Amdt. Dated: February 28, 2005
Reply to Office Action of: November 30, 2004

REMARKS/ARGUEMENTS

Amendments to the Drawings:

Fig. 8

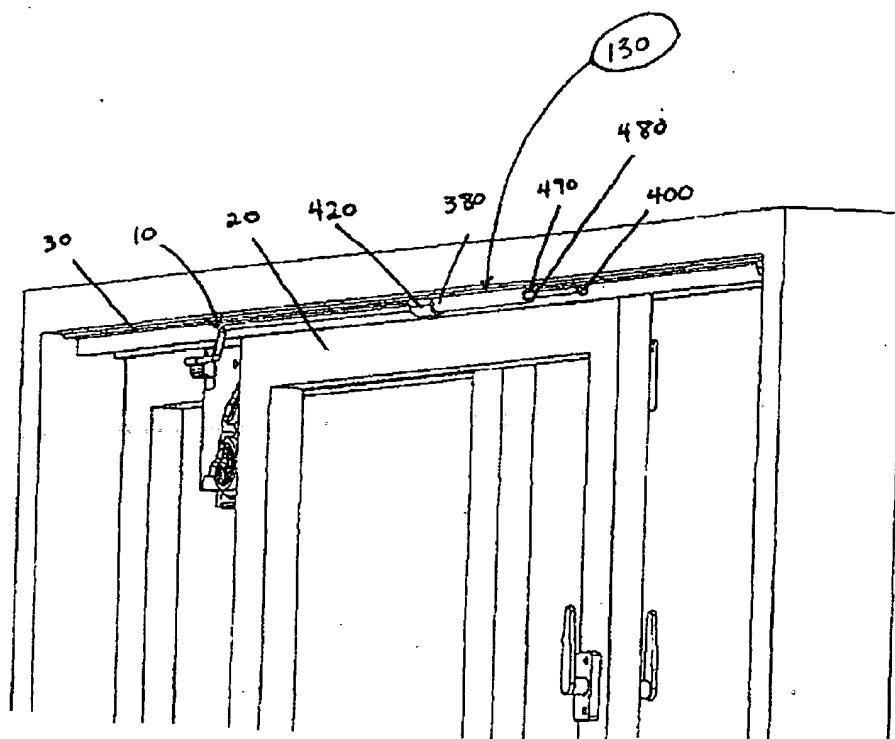
The Examiner objected to the drawings because they did not include reference numeral 130 mentioned in the description. Applicant has attached a replacement sheet to this amendment that includes reference numeral 130. Accordingly, applicant respectfully requests withdrawal of the objection in view of the corrected drawings attached to this amendment.

The attached sheet of drawings includes changes to Fig. 8. This sheet replaces the original sheet including Fig. 8. Previously omitted element 130 has been added.
